# UNITED STATES PATENT AND TRADEMARK OFFICE

APPLICATION NO.	FILING DATE	FIRST NAMED INVENTOR	ATTORNEY DOCKET NO.	CONFIRMATION NO.
09/518,421	03/03/2000	Victor Rossin	805.300US01	6283

**Office Action Summary**

## **DETAILED ACTION**

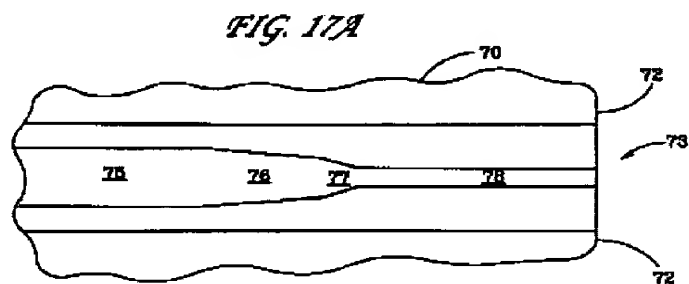
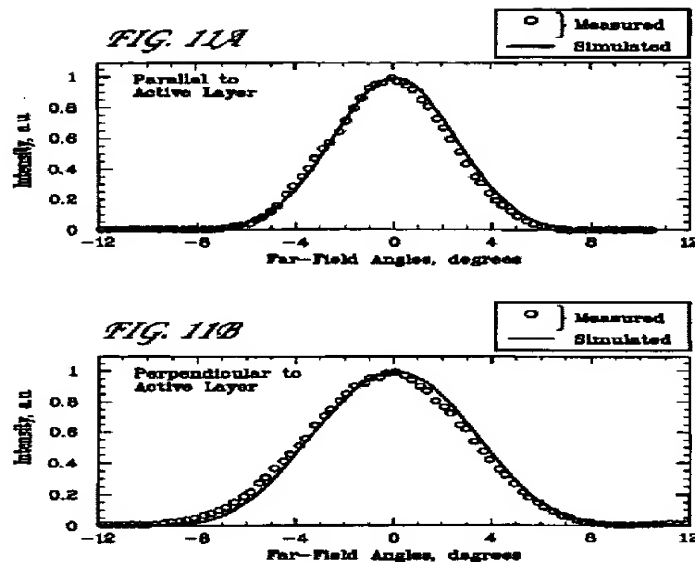
Figure 17 illustrates a semiconductor laser having a tapered waveguide for coupling to an optical fiber, the waveguide having three portions a wide portion (75), a tapered middle portion (76) and a narrow portion (78), as described in column 6 lines 30-39.

Figures 11A and 11B illustrate the far-field beam profile with a peak at 0 degrees and a constant slope, as described in column 9 lines 1-14.

Figures 2A-2C, 13A and 13B illustrate different widths for the tapered waveguide, as 2.4,1.2,0.7,3.0 and 1.0  $\mu\text{m}$ , respectively, which are within close range of the recited widths of applicants invention.

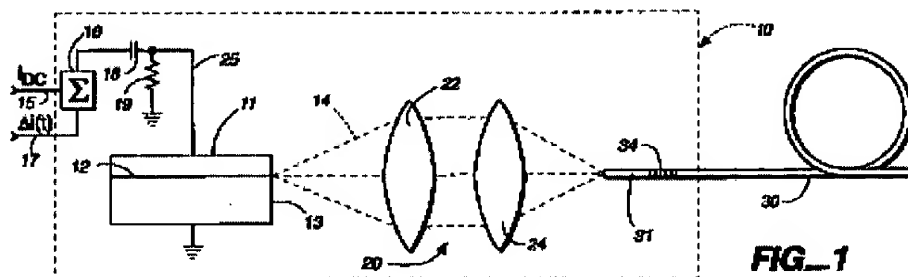
Vawter et al discloses coupling the laser system to a fiber, but fails to disclose the fiber having a wavelength selection grating.

Ventrudo discloses coupling a laser system to a fiber having a grating.

Ventrudo illustrates in figure 1 a semiconductor laser (11) coupled via lenses (22,24) to an optical fiber (31), which contains a rare earth active gain medium (30) and a Bragg grating (34) positioned at 2cm to 3cm from the laser facet and having a reflectivity not exceeding 10%, as described in column 4 lines 19-67. In the abstract and columns 5 and 7 Ventrudo discloses the grating is provided at distance from the laser for causing the system to switch between the coherence collapse and coherence state.
